## **ANTHONY DEARBORN SUBDIVISION**

APPLICATION NUMBER 5 DATE December 1, 2016

REQUEST Subdivision

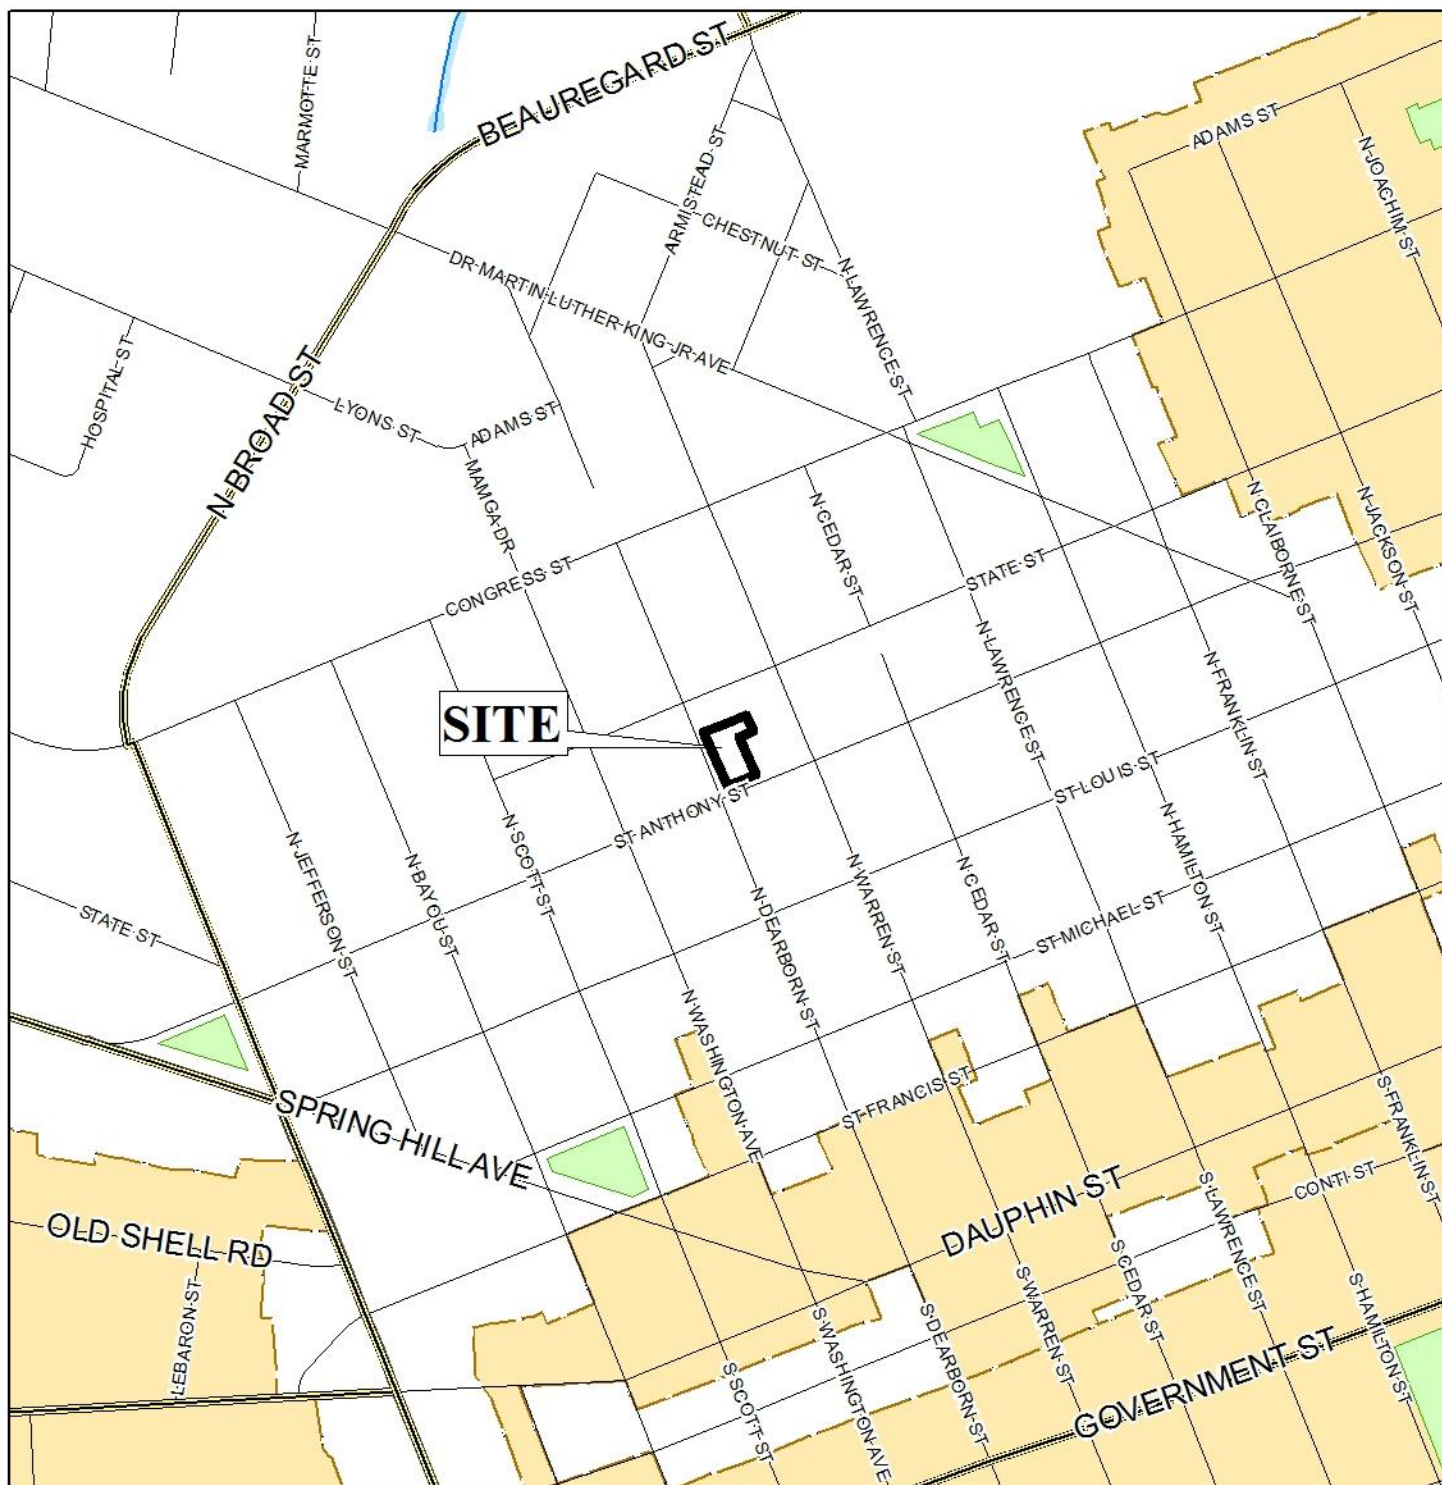
- A. Provide all of the required information on the SUBDIVISION PLAT (i.e. signature blocks, signatures, certification statements, written legal description, required notes, legend, scale, bearings and distances) that is required by the current Alabama State Board of Licensure for Professional Engineers and Land Surveyors.

- B. Review and revise the written legal description to match the written bearings and distances.
- C. Dedicate the corner radius (25' minimum or as approved by the City Engineer and Traffic Engineer) at the Southwest corner of LOT A.

- D. Show and label all flood zones.
- E. Show and label the MFFE (Minimum Finished Floor Elevation) on each lot that contains an AE, V, or X (shaded) flood zone designation.

- F. Provide and label the monument set or found at each subdivision corner.
- G. Add a signature block for the Owner, Notary Public, Planning Commission, Traffic Engineer, and City Engineer.

- H. Provide the Surveyor's Certificate.
- I. Add a note to the SUBDIVISION PLAT stating that a Land Disturbance permit will be required for any land disturbing activity in accordance with Mobile City Code, Chapter 17, Storm Water Management and Flood Control); the City of Mobile, Alabama Flood Plain Management Plan (1984); and, the Rules For Erosion and Sedimentation Control and Storm Water Runoff Control.

- J. Add a note to the Plat stating that the approval of all applicable federal, state, and local agencies (including all storm water runoff, wetland and floodplain requirements) will be required prior to the issuance of a Land Disturbance permit.

- K. Add a note that sidewalk is required to be constructed, and/or repaired, along the frontage of each lot, or parcel, at time of new development or construction, unless a sidewalk waiver is approved.

maximum curb cut width is 25'. The site should be limited to one curb cut per street frontage with size, location and design to be approved by Traffic Engineering and conform to AASHTO standards. The curb cut along North Dearborn Street should be modified to only be 25' in width, with the sidewalk and curb and gutter restored.

There is no minimum building setback required in a SD-WH district; however, the lot is limited to a 10' maximum building setback. Therefore the plat should be revised to indicate the 10' maximum building setback line along all street frontages and include a note stating that a 0' setback is allowed. It should be noted that such a setback varies from Section V.D.9. of the Subdivision Regulations, and waiver of such would be required and in order.

The site, which is developed, also contains surface parking. Section 64-3.I.11.(b)(3) of the Zoning Ordinance requires that parking lots be screened. Thus, the plat should be revised to depict compliant screening along all street frontages.
